Planning and Zoning Board Agenda January 12, 2021

SUBJECT:	A request for consideration of a Final Plat of Dogwood Acres – Lot 12A, being a replat of Lot 12A of Dogwood Acres – First Addition Replat as recorded in Plat Book 22, Page 73 of the Public Records of Alachua County, together with a 30 foot strip adjacent to the west line of Lot 12A (minor subdivision review)
APPLICANT/AGENT:	Stacy Hall, P.S.M, George F. Young, Inc.
PROPERTY OWNER:	John A. Sapp and Antoinette Pratto-Sapp
PARCEL ID NUMBER:	03013-020-012
FLUM DESIGNATION:	Moderate Density Residential
ZONING:	Agricultural (A)
OVERLAY:	N/A
ACREAGE:	±3.93
PROJECT PLANNER:	Justin Tabor, AICP
RECOMMENDATION:	Staff recommends that the Planning & Zoning Board transmit the final plat of Dogwood Acres – Lot 12A to the City Commission with a recommendation to approve.
RECOMMENDED MOTION:	<i>Based upon the competent substantial evidence presented at this hearing, the presentation before this Board, and Staff's recommendation, this Board finds the application to be consistent with the City of Alachua Comprehensive Plan and in compliance with the Land Development Regulations and transmits the final plat of Dogwood Acres – Lot 12A to the

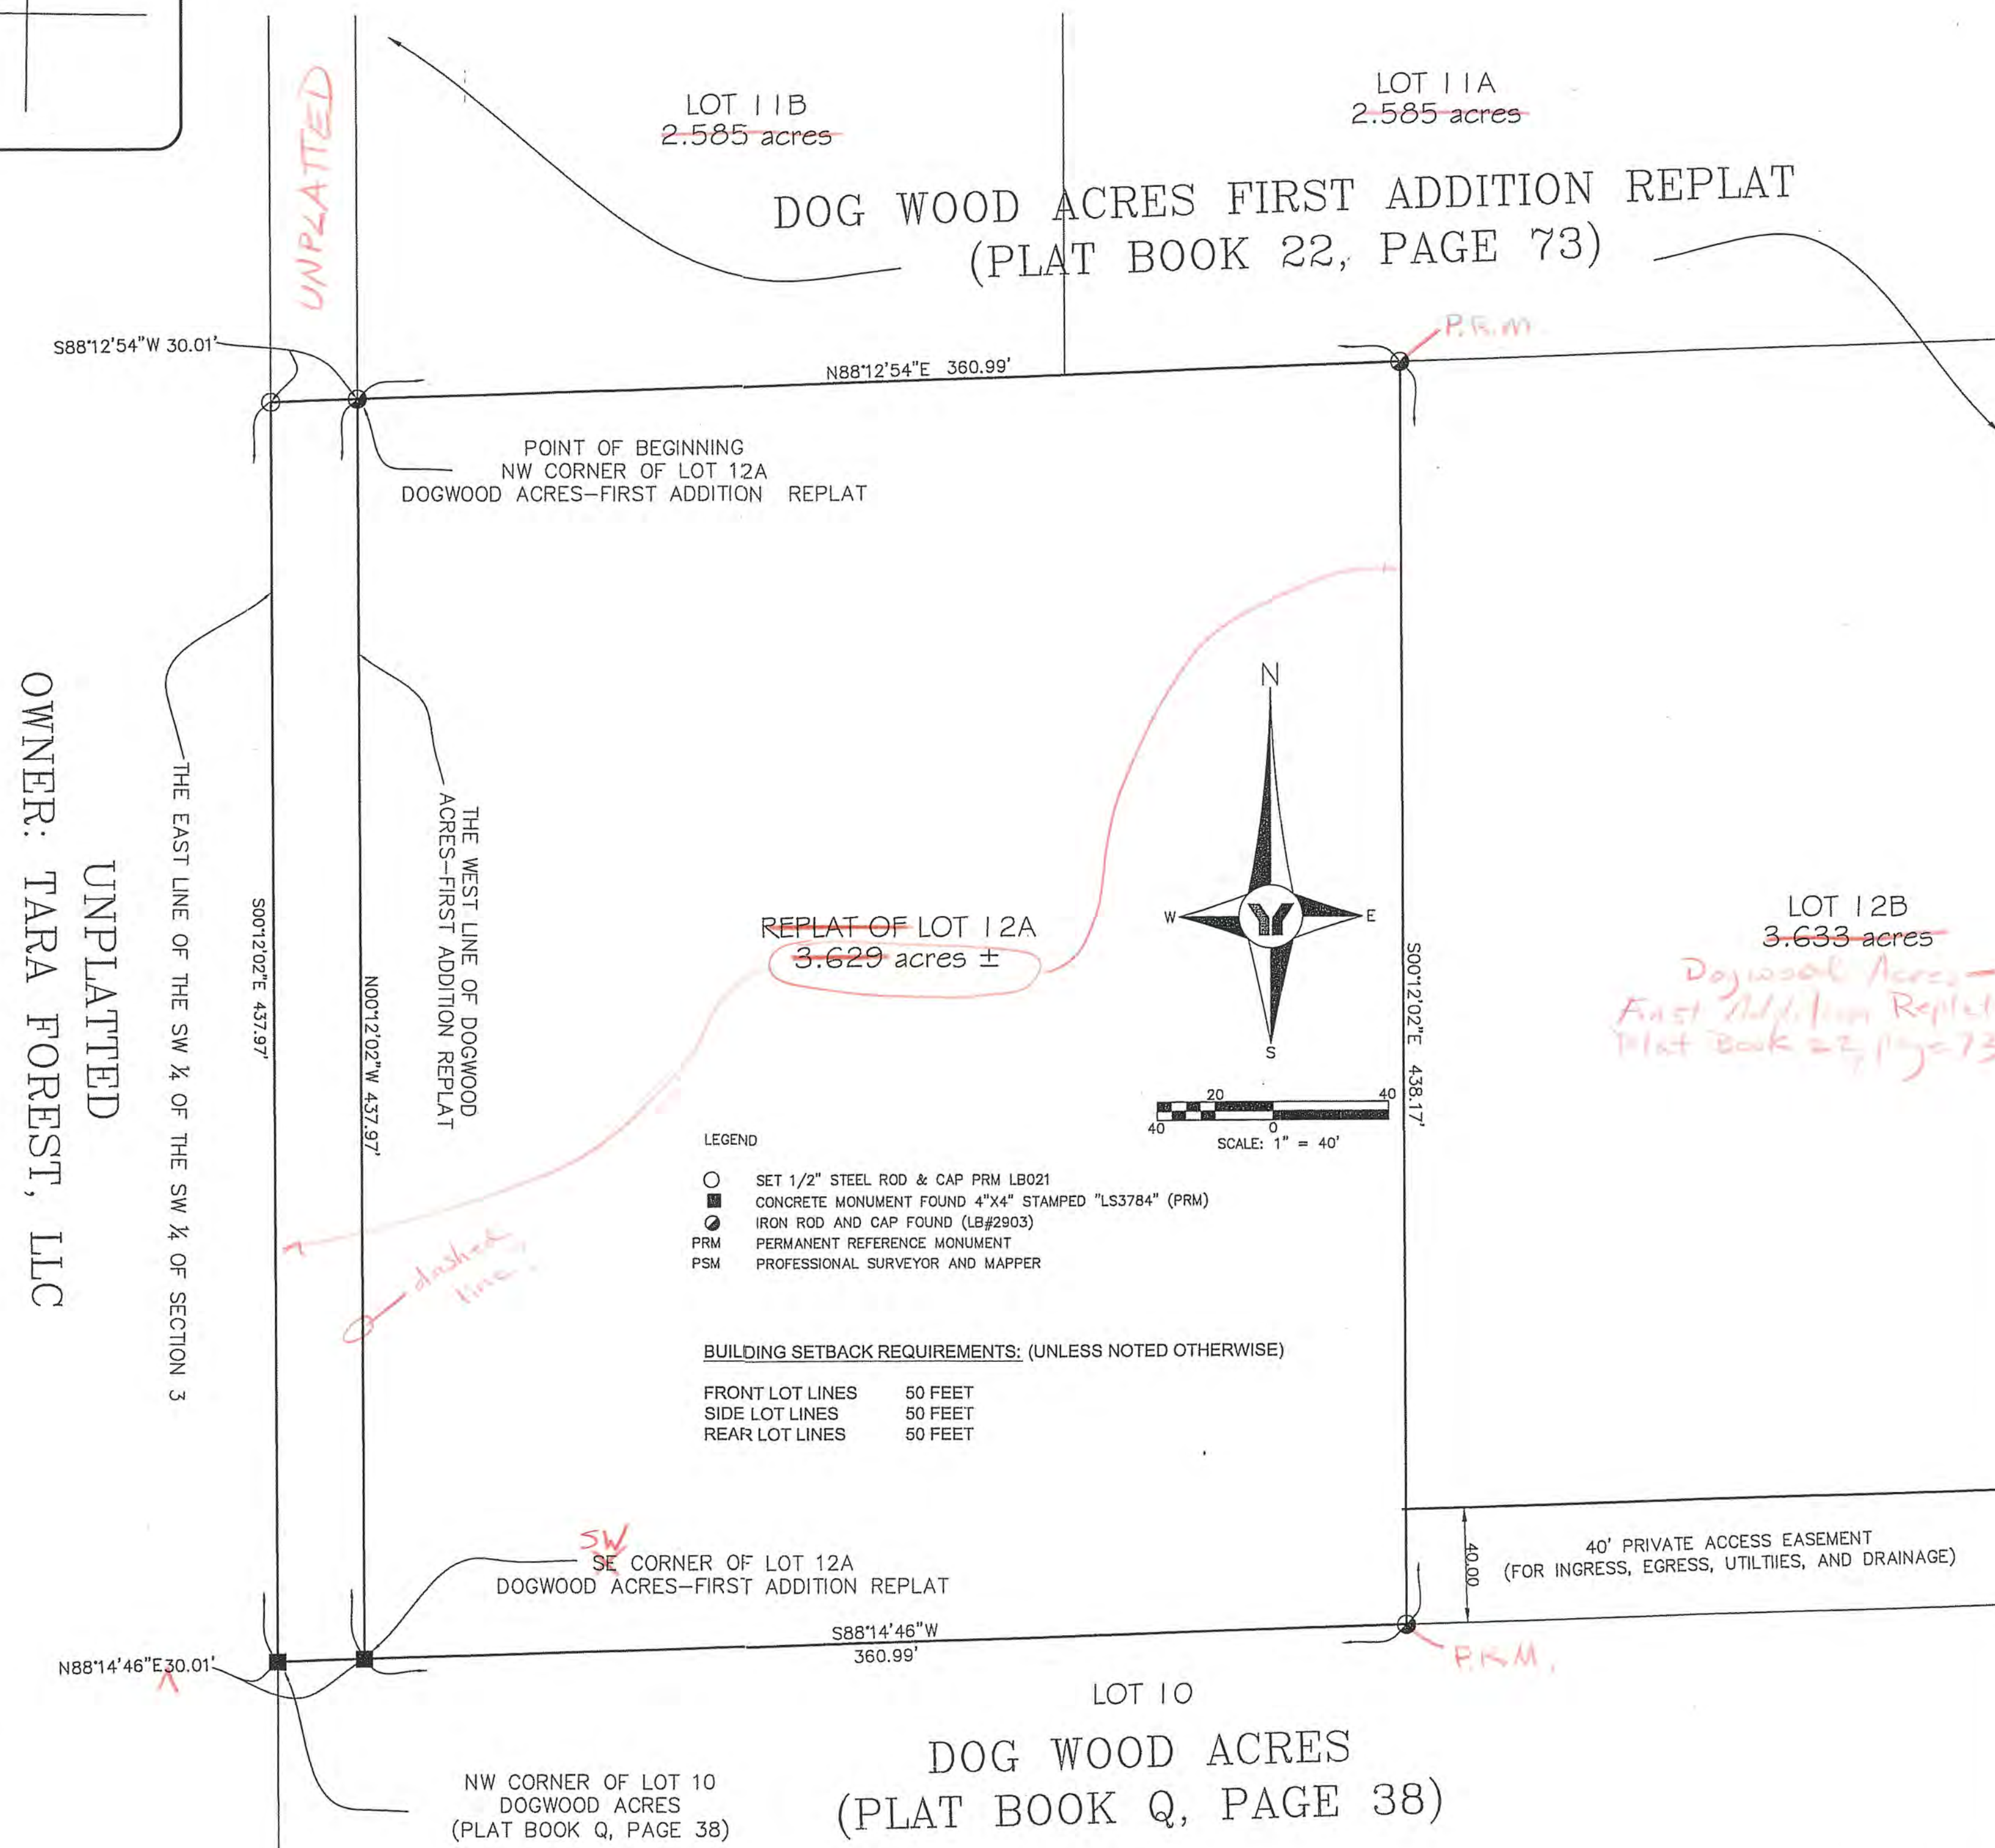
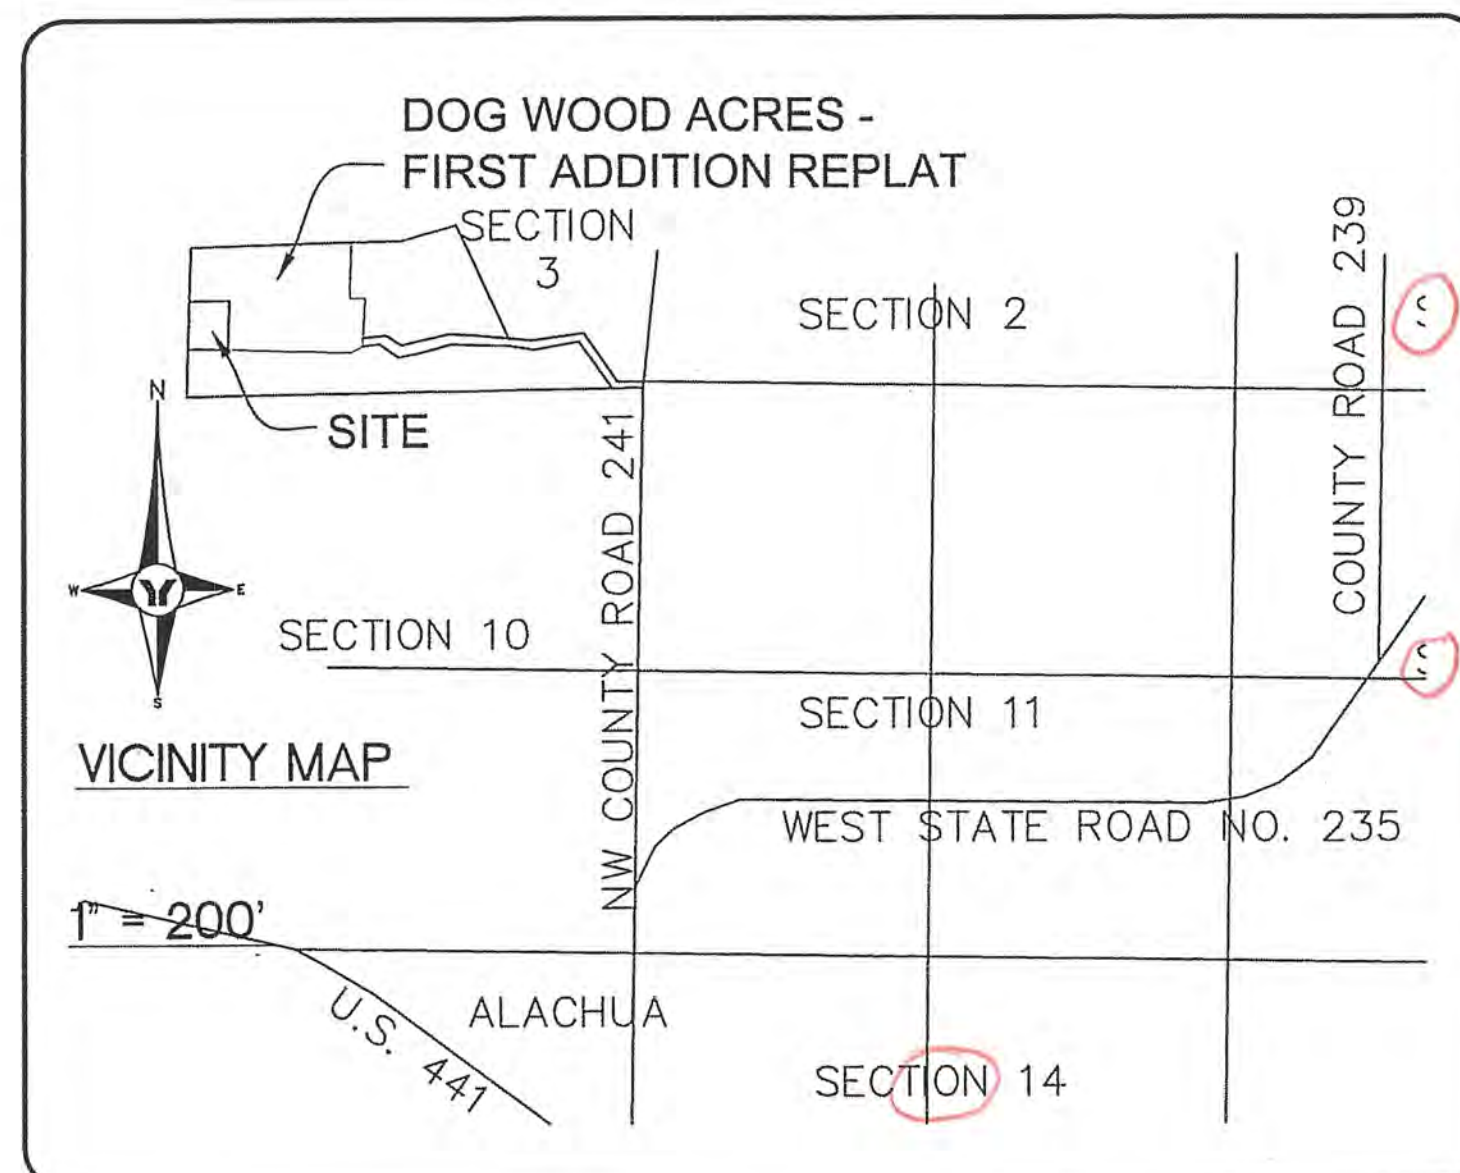
1. Chapter 177, Florida Statutes
 - a. 177.091(11): Each plat shall show a description of the lands subdivided, and the description shall be the same in the title certification. The legal description attached as Exhibit "A" to the title certification does not include the "together with" and header language for the 30' strip of land.
2. Miscellaneous
 - a. Name of the plat in owners certification does not match the name of the plat used in the title block.

- a. There is a typographical error in the first sentence of the owners certification (present-s).
- b. Add lines for the date to be inserted for signature block and date for John Sapp and Antoinette Pratto-Sapp in the owners certification.
- c. Add signature lines for two witnesses for both John Sapp and Antoinette Pratto-Sapp in the owners certification.
- d. Delete the period after Antoinette Pratto-Sapp in the acknowledgment of the owners certification.
- e. The acknowledgment of the owners certification should use plural nouns and pronouns ('drivers licenses' and 'they').
- f. The year in the notary block of the acknowledgement of owners certification should be 2021.
- g. The year in the certificate of approval by the Clerk of the Court should be 2021.

Basin Details	
Designed: DJM	Sheet No.:
Drawn: DLW	C210
Checked: TAR	
Date: 12/07/20

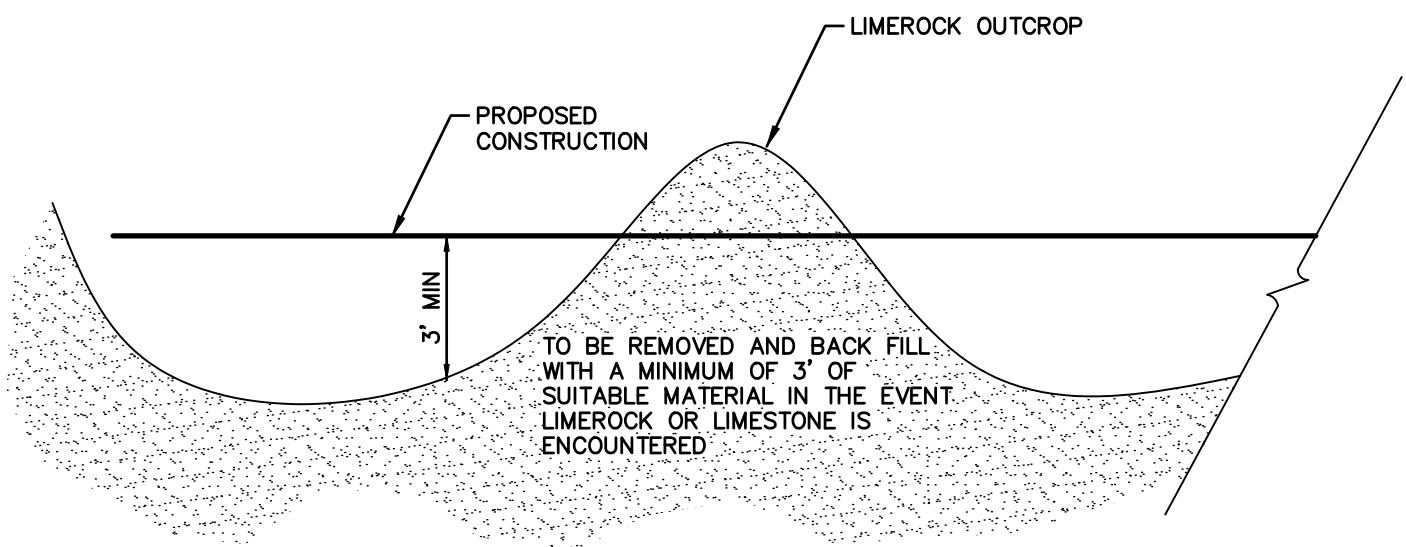
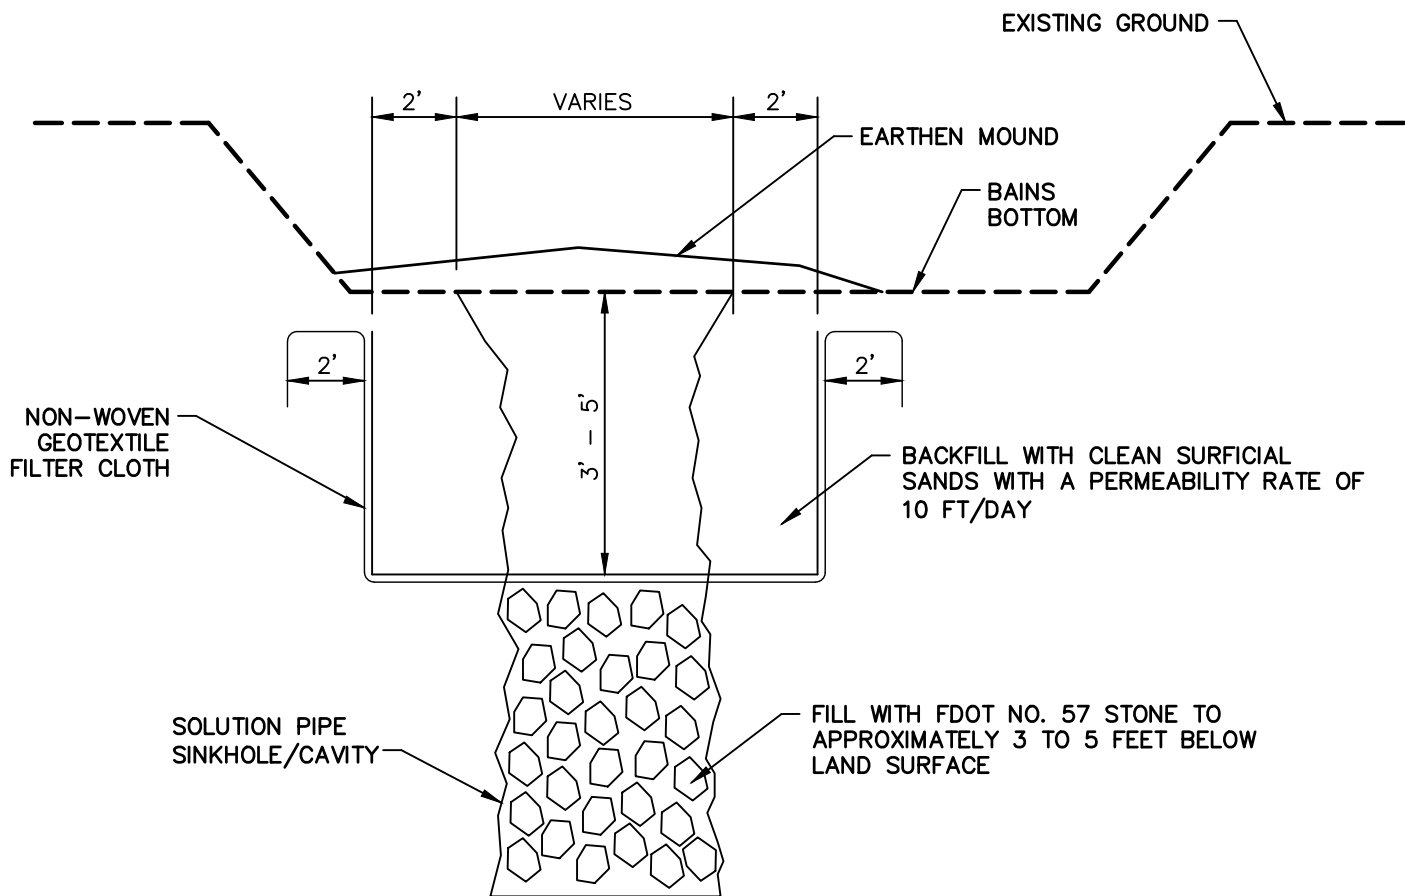
8. Does topo exist to document that grade falls away east of the 20' sodded weir overflow? Topo in this area is not shown on Sheet C210.

8. Does topo exist to document that grade falls away east of the 20' sodded weir overflow? Topo in this area is not shown on Sheet C210.
